UI BULLETIN # 90b

SUBJECT: Chassis Cab Fuel Filler Assembly `Service Body`
Installation Guide

MODELS AFFECTED: Chevrolet Silverado, GMC Sierra ALL
With RPO ZW9 or Pick Up Box Removal

Diesel Chassis Cab up-fit recommendation

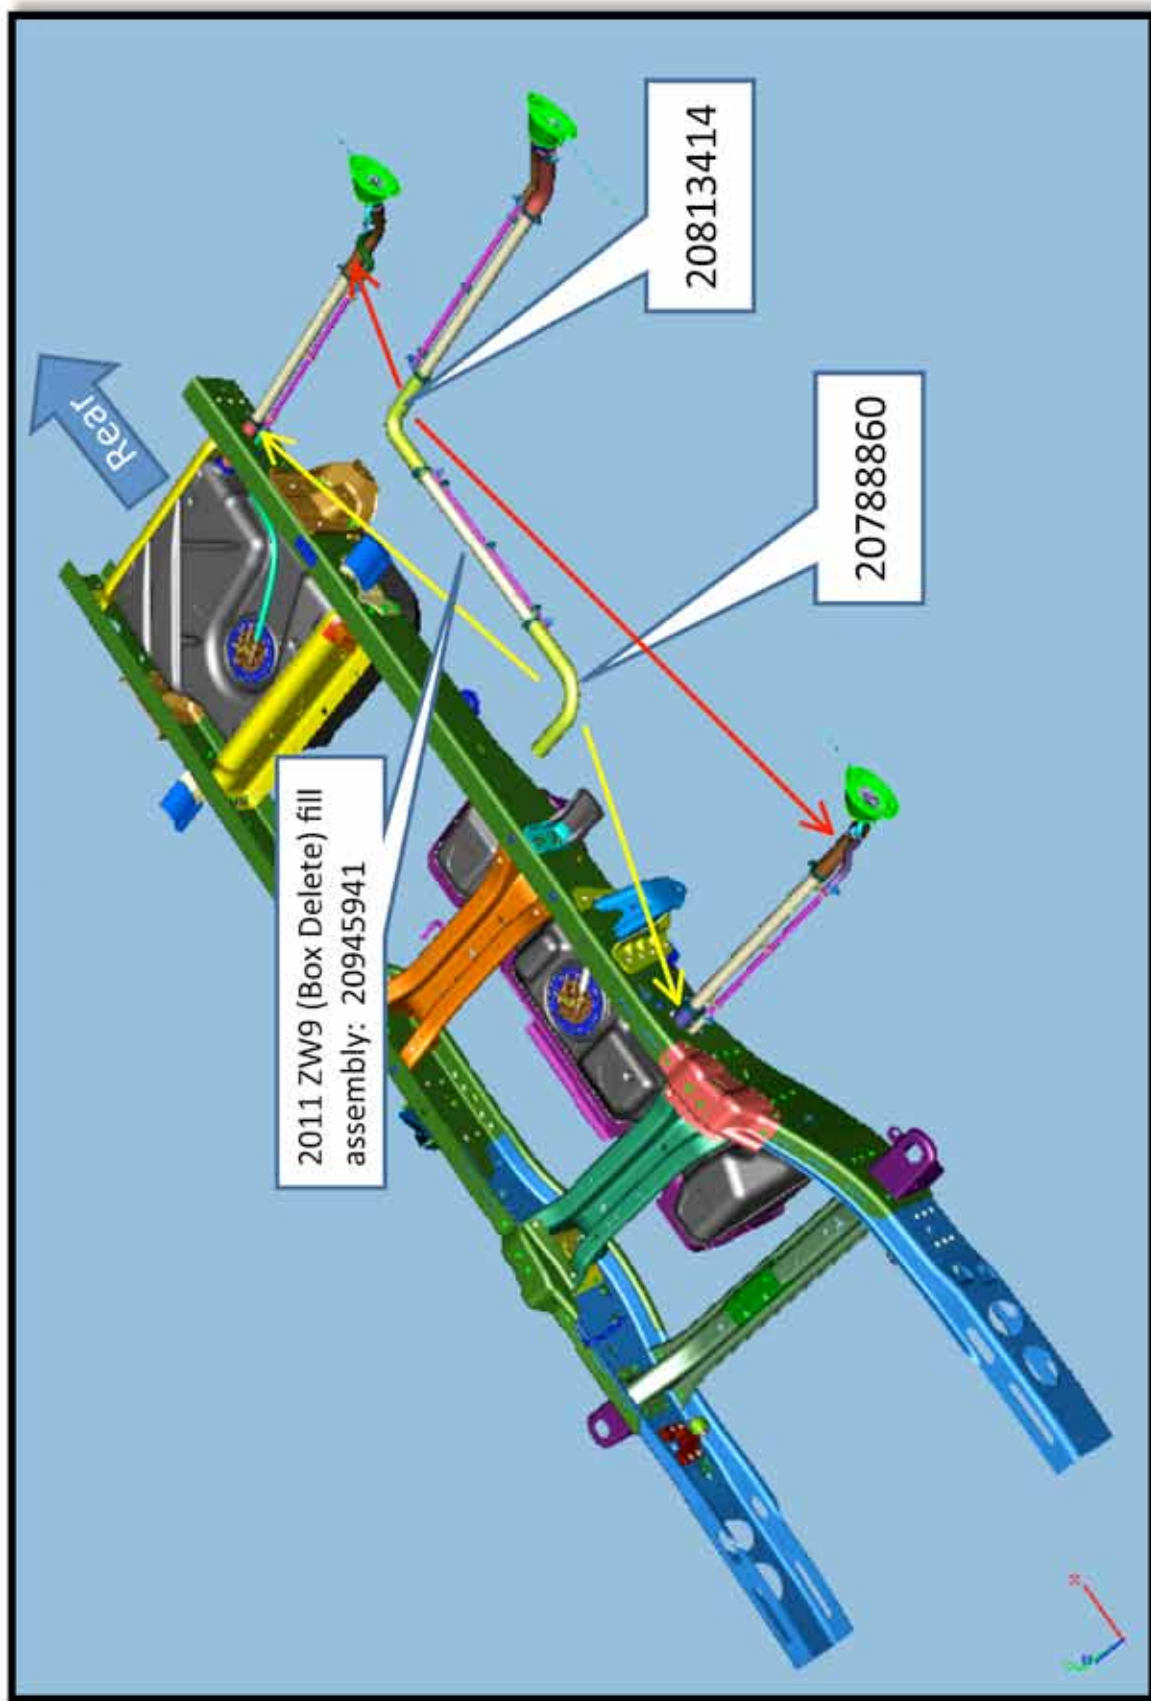
- Replace lower fill hose with (20788860) (see page 2)
- Replace upper fill hose with (20813414) (see page 2)
- Trim as necessary
- Maintain clamp torque (4 +/- .5 Nm)
